Subject: TN West Review Comments of the Preliminary Certificate of Compliance and Safety Evaluation Report for Standardized NUHOMS® System 61BT DSC Amendment

Comments on the Preliminary NUHOMS<sup>®</sup> CoC (61BT DSC Amendment)

Comments on the SER (61BT DSC Amendment)

**Figure K.1-1**  
**NUHOMS® -61BT DSC Components**

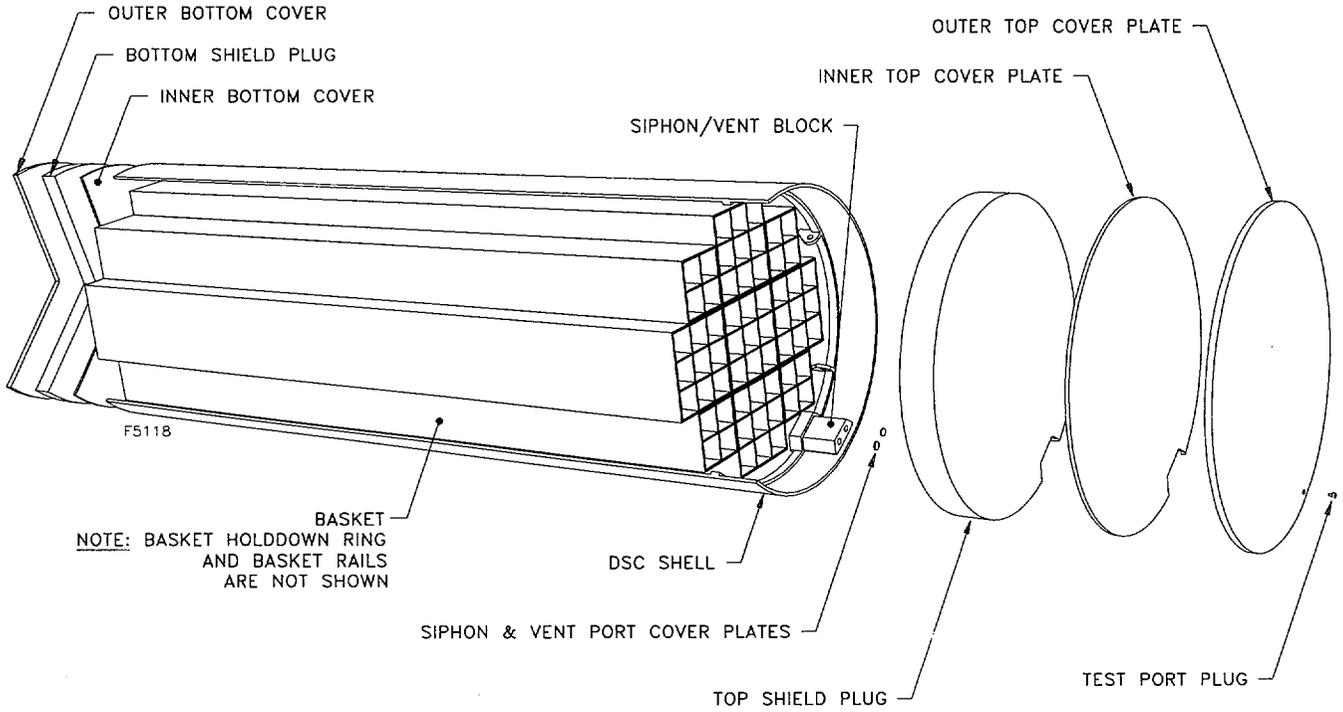
1. Revise Figure 1 to change the term “Vent Port Plug” to “*Test Port Plug*” to be consistent with the drawings included in Chapter K.1.5 of the SAR. A revised version of SAR Figure K.1-1 showing the correct description is included with this submittal.
2. Page 1-1, para 1.1: Revise second sentence to say “*Boral*<sup>®</sup>, borated aluminum or boron carbide/aluminum metal matrix composite plates provide criticality control ..”
